RE: Stormwater Review Baronne Street Hotel 1426 Baronne Street Reference Code: SVA7HG H/S Project No. 21009

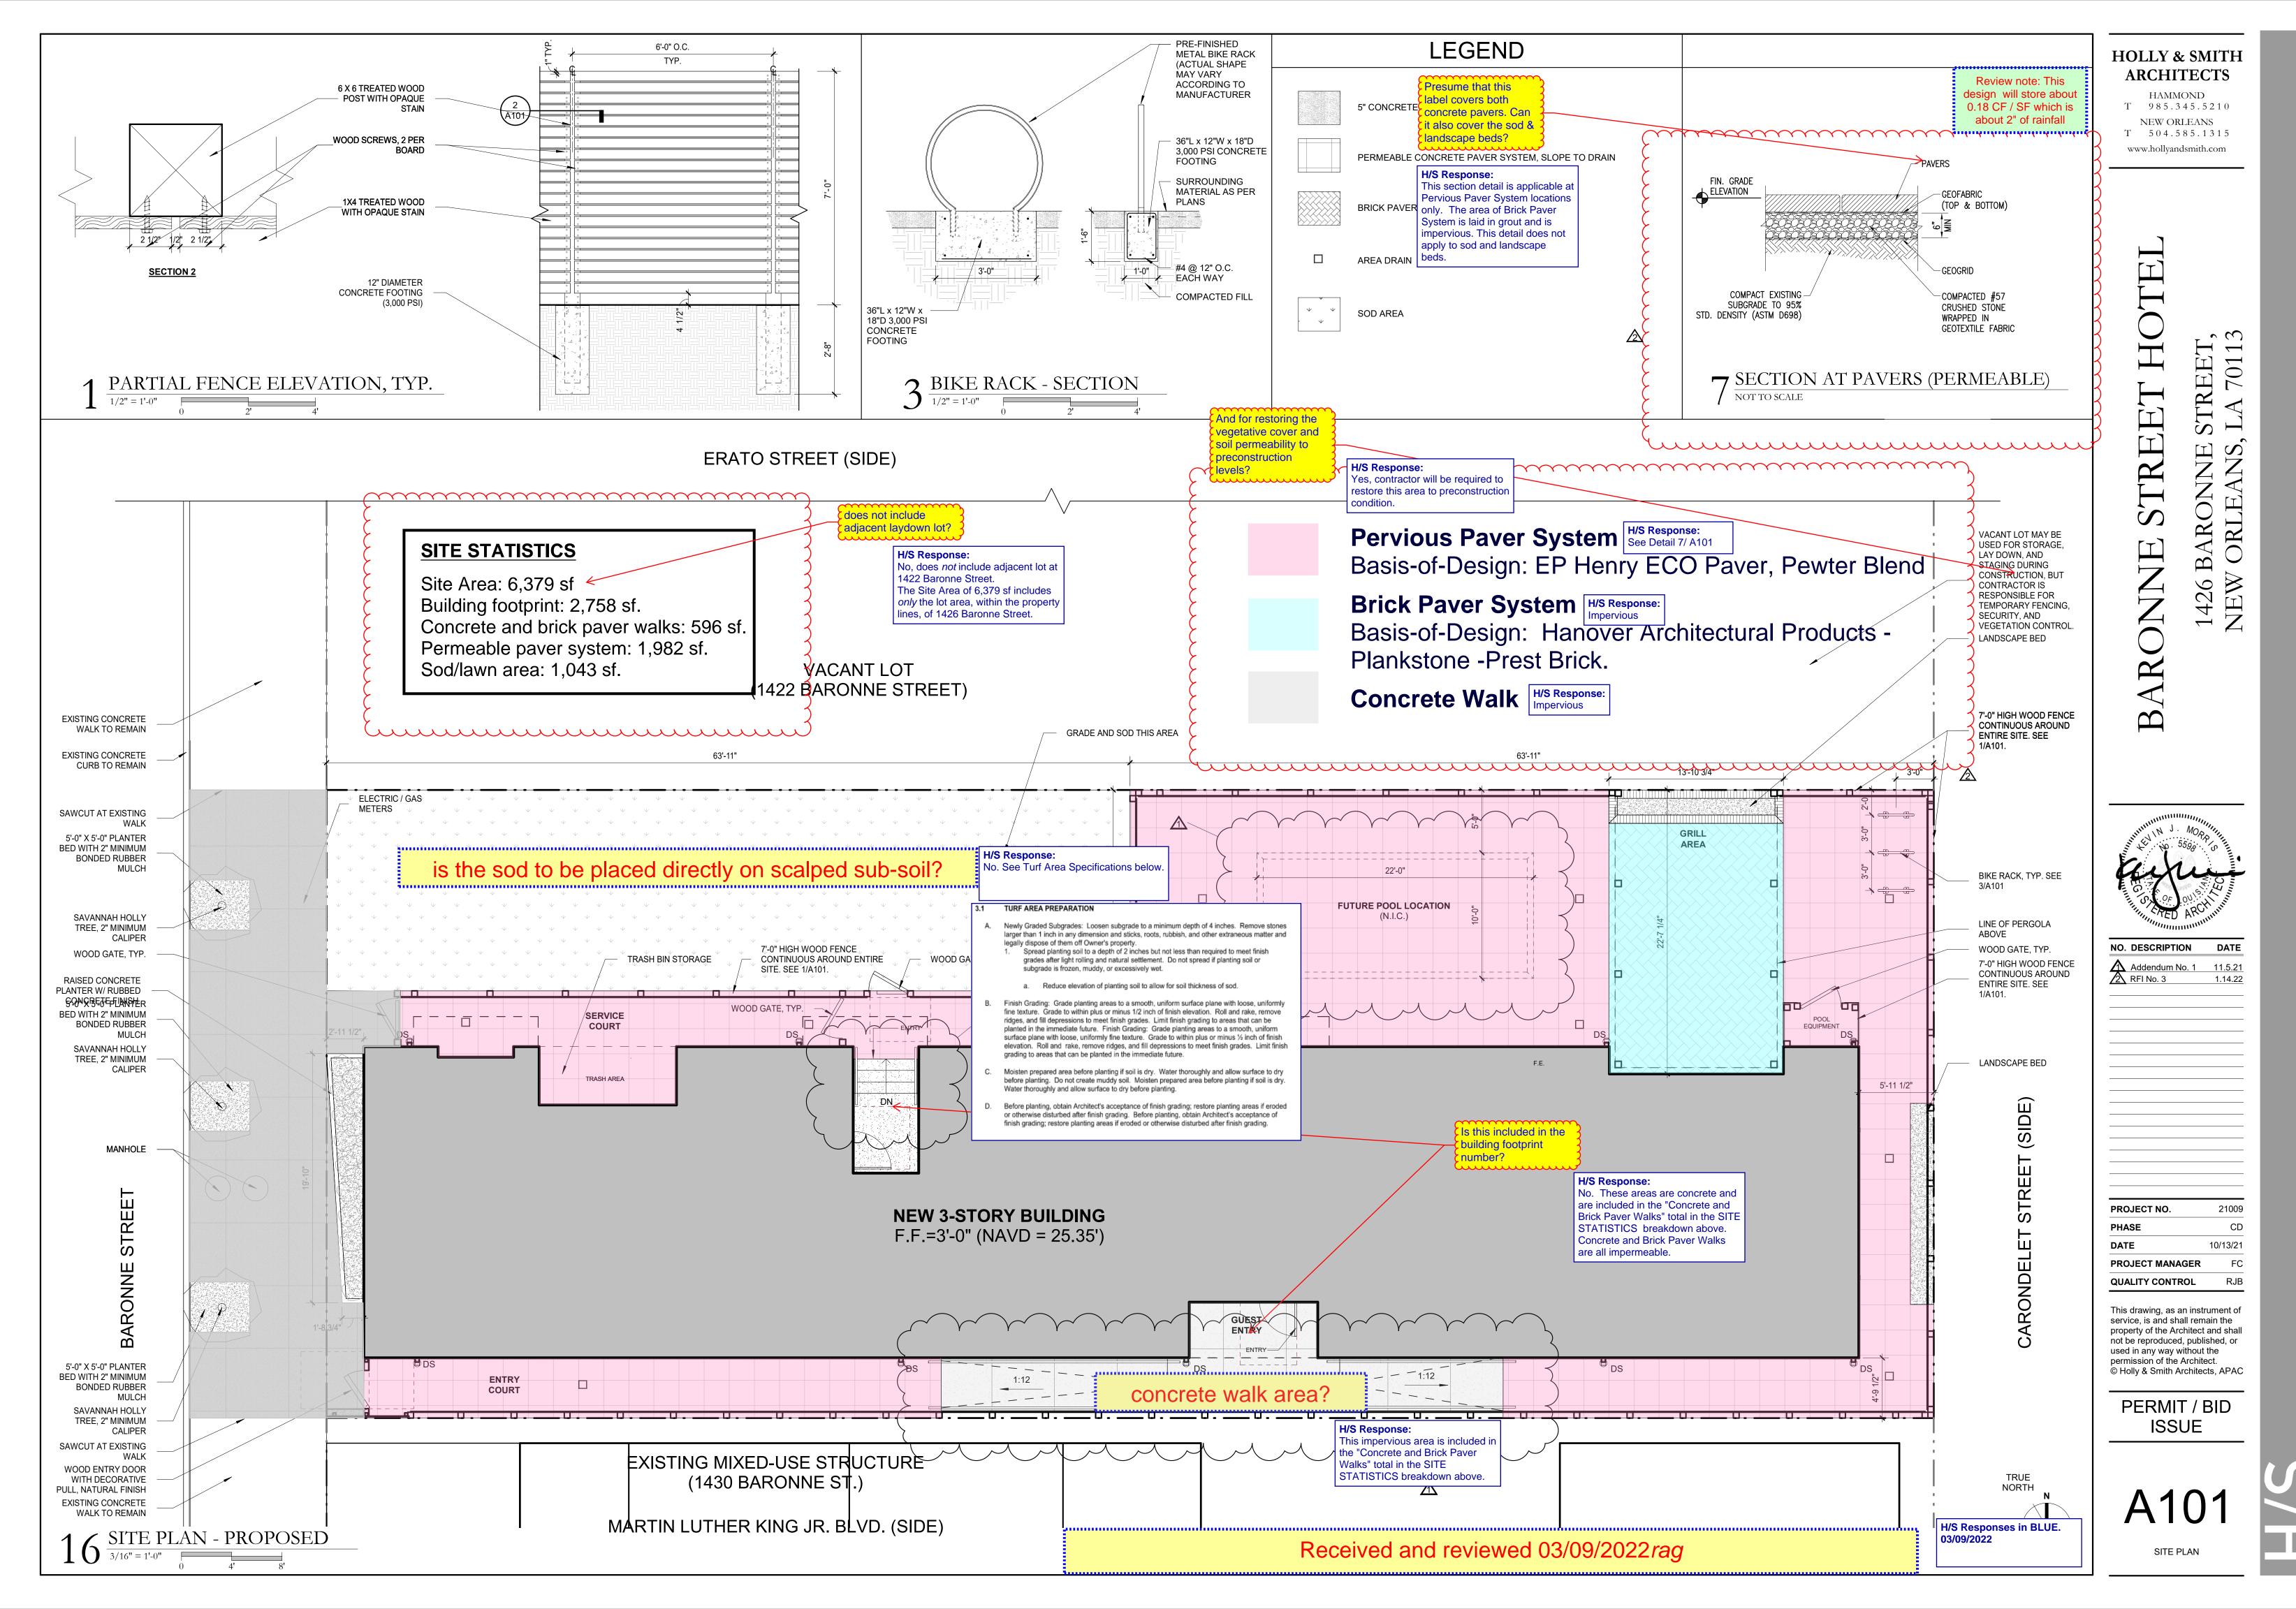
Please accept this letter in response to the stormwater review comments for our project at 1426 Baronne Street. The review comments require submittal of a completed Stormwater Management Plan (SWMP). Per City Code Section 26-15, a SWMP is required if any of the following:

We believe the proposed project is does *not* meet the conditions that would require a SWMP:

- 1. The proposed project includes only 3,354 sf of impervious area.
- 2. The site is currently undeveloped.
- 3. The site is less than one acre.
- 4. The principal us of the site is commercial/hotel, not stormwater management.

For reference, attached is a copy of the site plan with the location and area of each paving type.
